Product hierarchy no. *			Part no.	SBU	Type / Description	Customer part no.
SBU PG	PGU	Type				
90	004	001	0000001000	See list below	Voltage Selector	SWP

Modification of approval marks, extension of operating-cycle and -temperature markings.

SWP					0118.2278	
creation date	created by	release date	released by	notification no.	revision	page
2015-04-07	schaidro	2015-05-12	schaidro			1 of 2

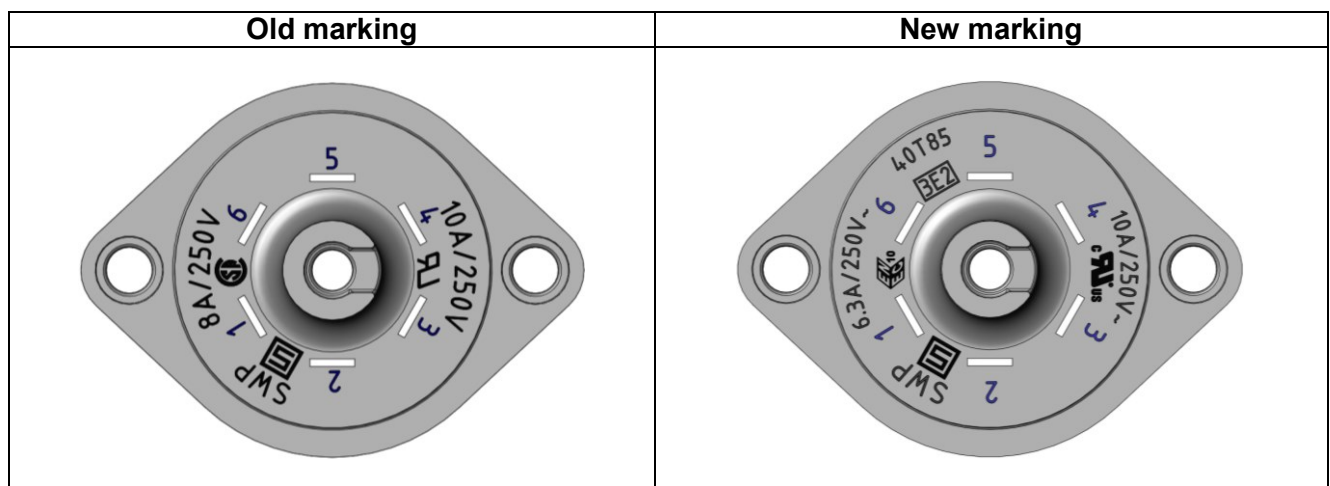
Old marking	New marking
-	ENEC 10 6.3A/250V~
-	3E2 ¹
-	40T85 ²
UR 10A/250V CSA 8A/250V	cURus (combined) 10A/250V~
¹ 3E2 ~ Lifetime of 300 operating cycles	
² 40T85 ~ Allowable Operation Temp. -40°C to 85°C
